Richard W. Veyna
ASSOCIATES
Horticultural Consultants

February 21, 2024

Ping Wei
2907 Rio Lempa Dr.
Hacienda Heights, CA 91745

Tree #3

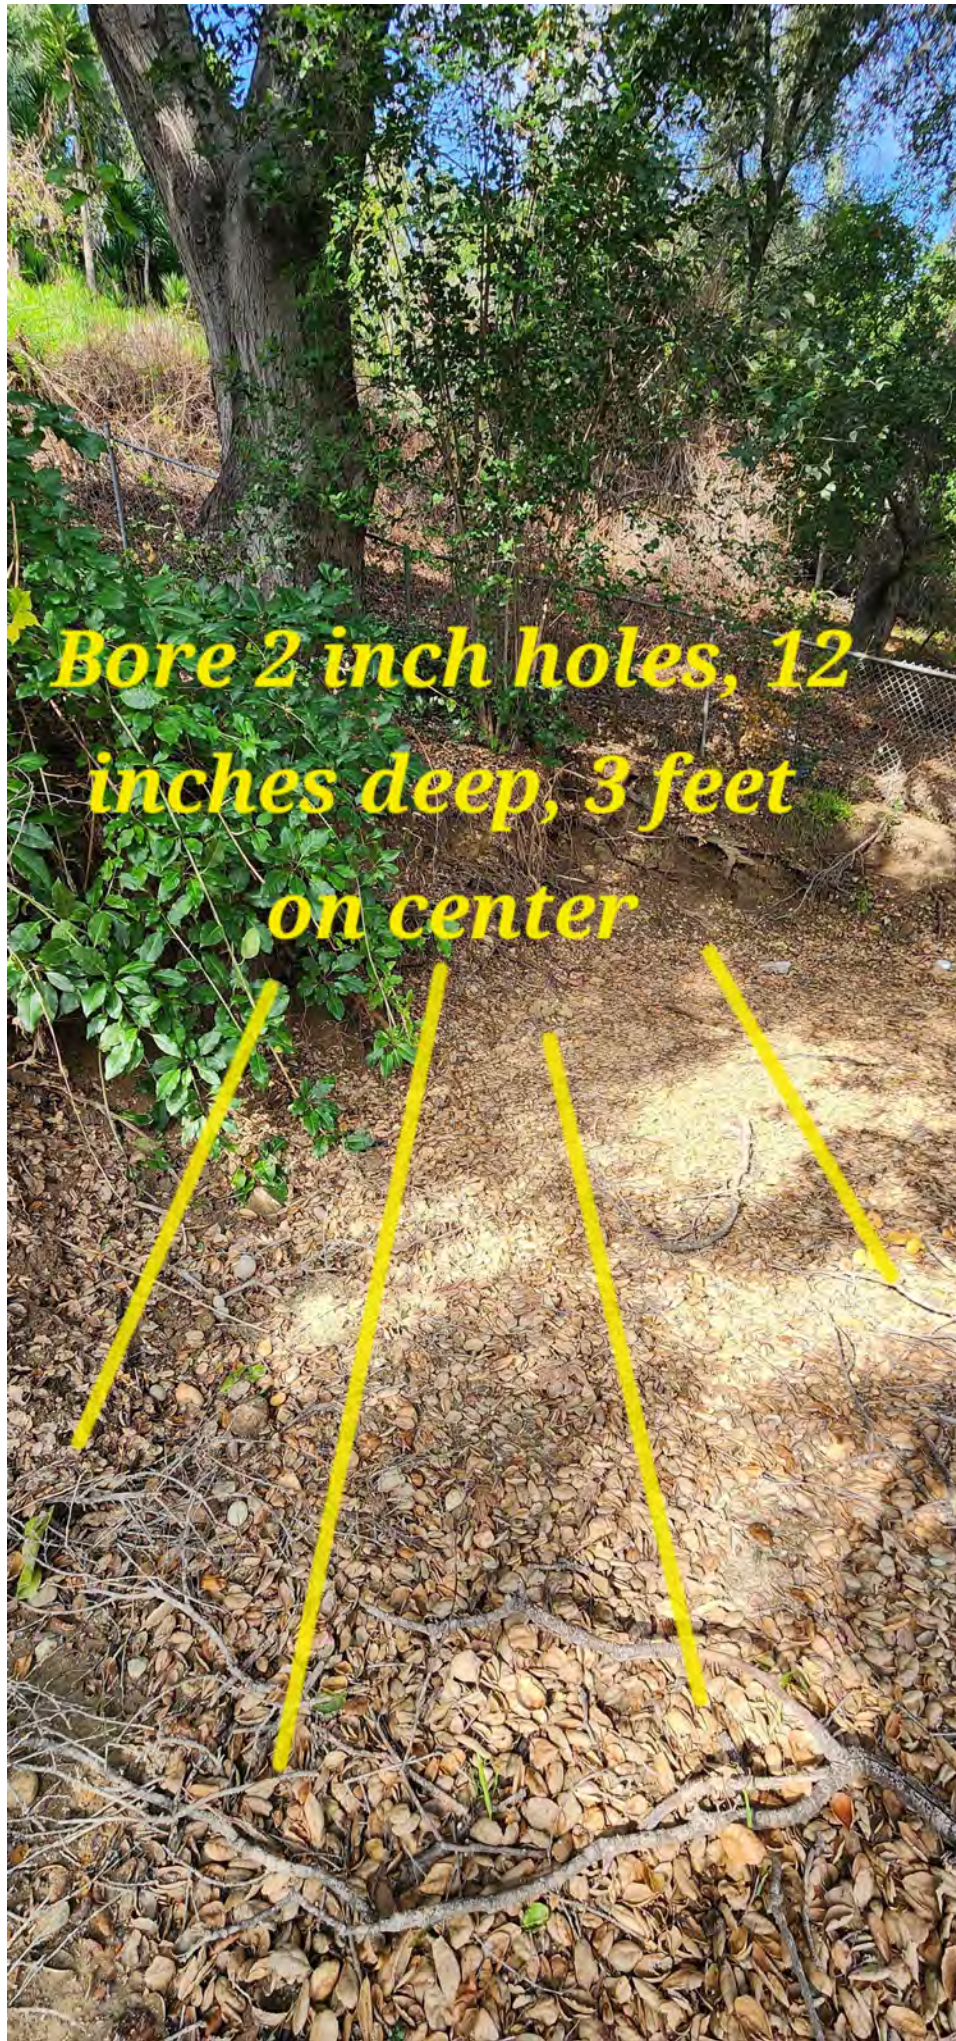
Which tree
is this?

*Excessively
compacted*

Which tree is this? A site plan for the bore holes would be helpful. What does "3 feet on center" mean? How many bore holes? I'm not going to assume 4 holes just because there are 4 yellow lines.

Bore 2 inch holes, 12 inches deep, 3 feet on center

Tree #2

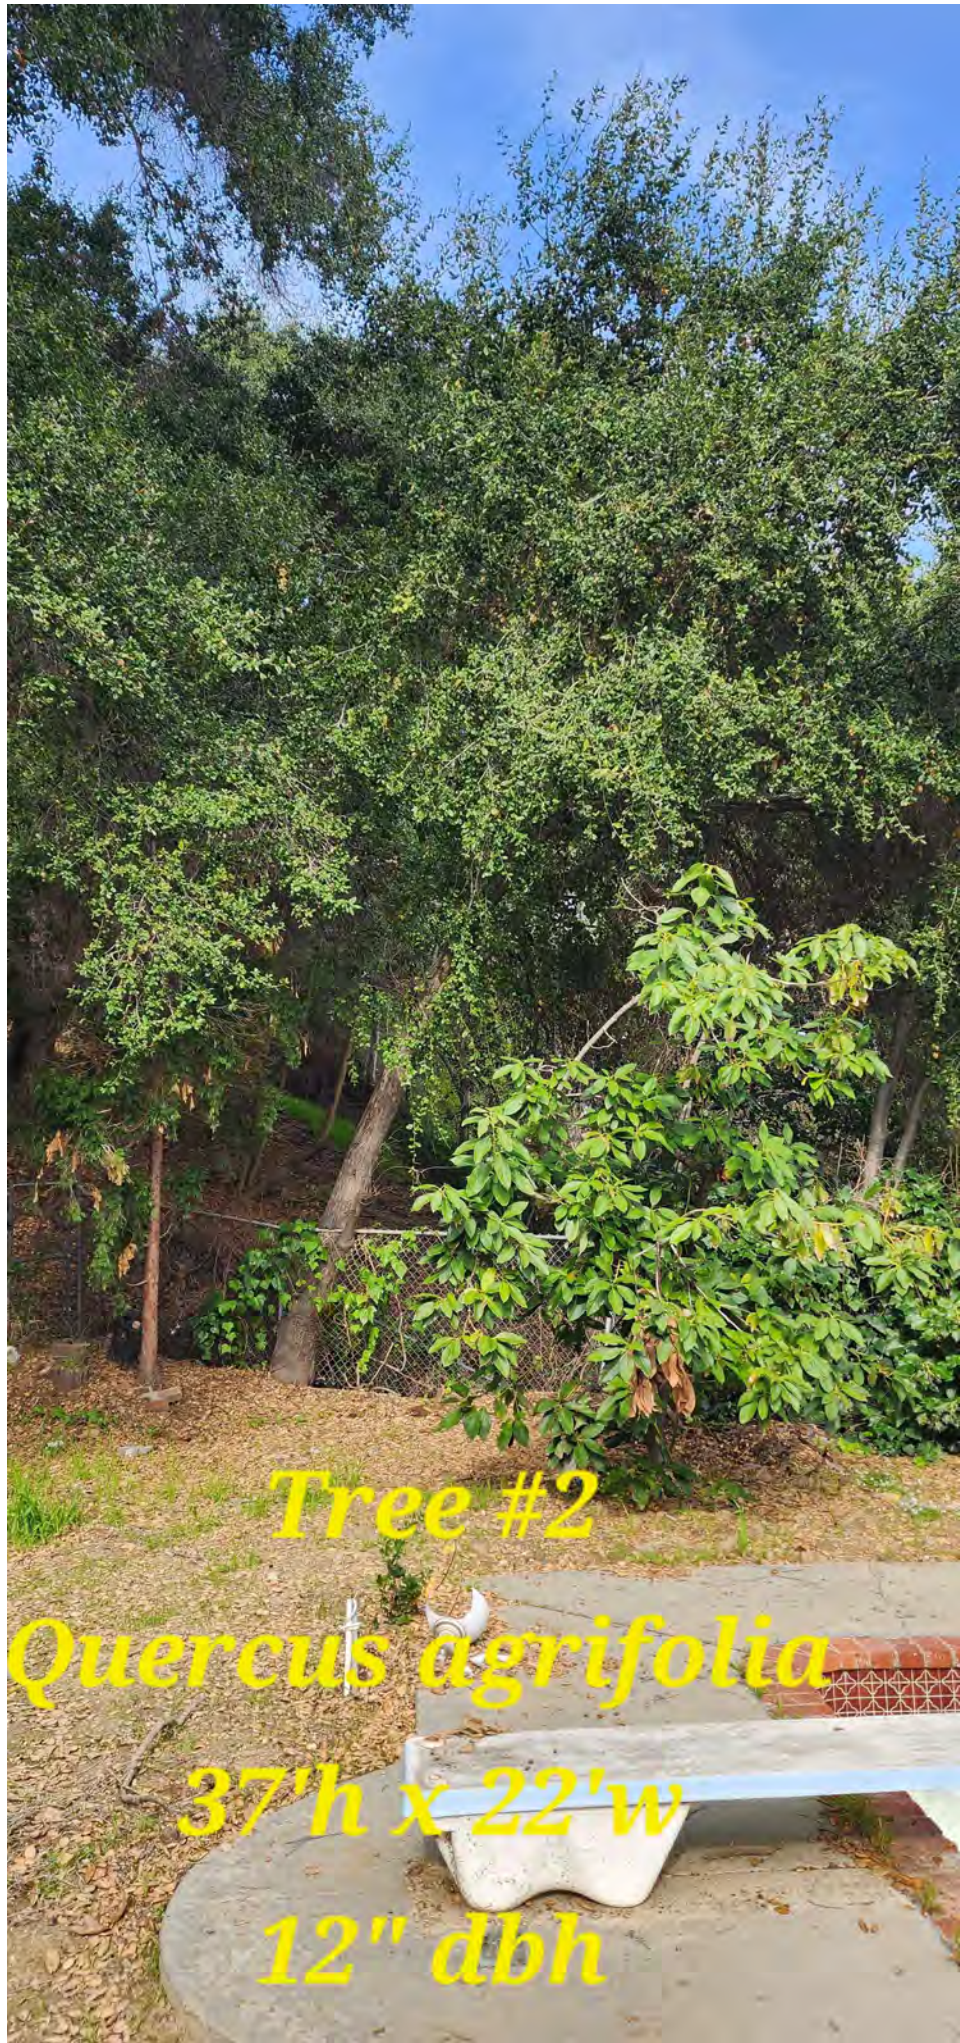
How does this help? Where would it go?

This "barrier" was not in place when I conducted my site visit.

Where?
No better
photo than
this?

A graduated block wall may be in order

Tree #1

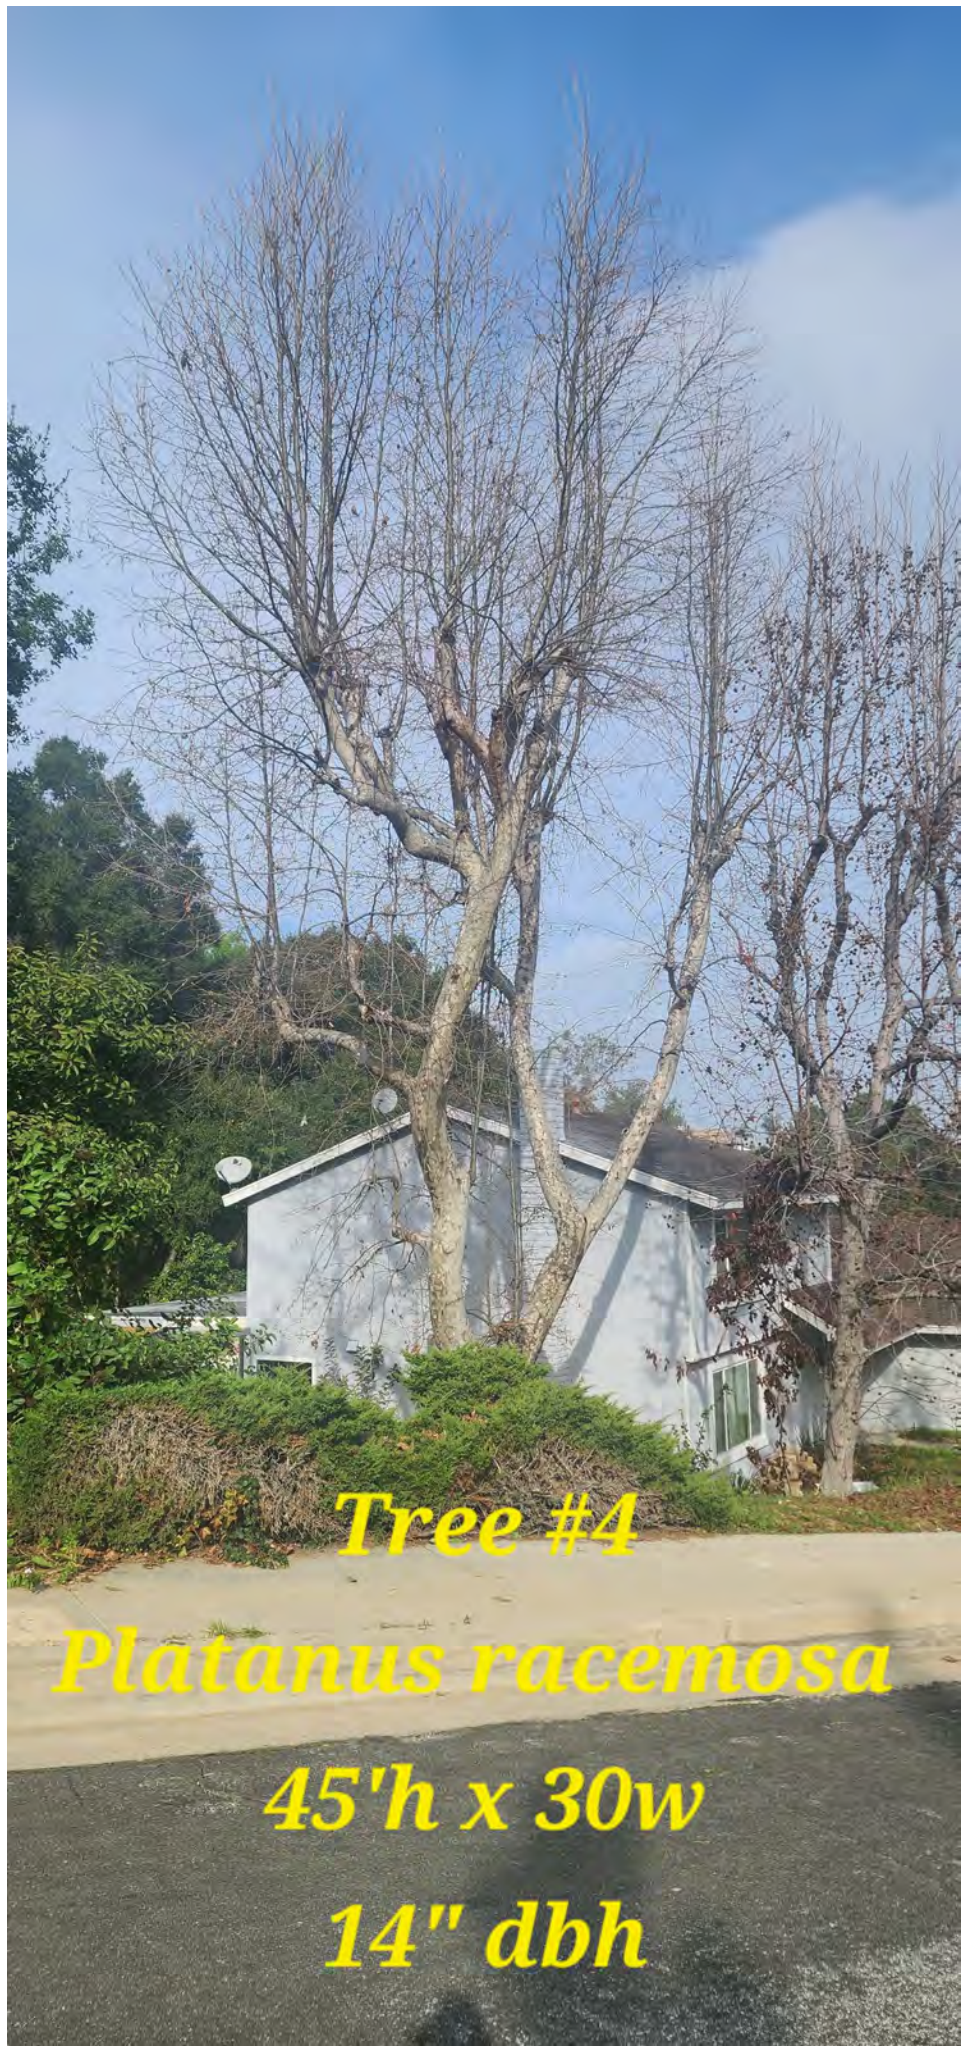
How would the proposed retaining wall impact this tree?
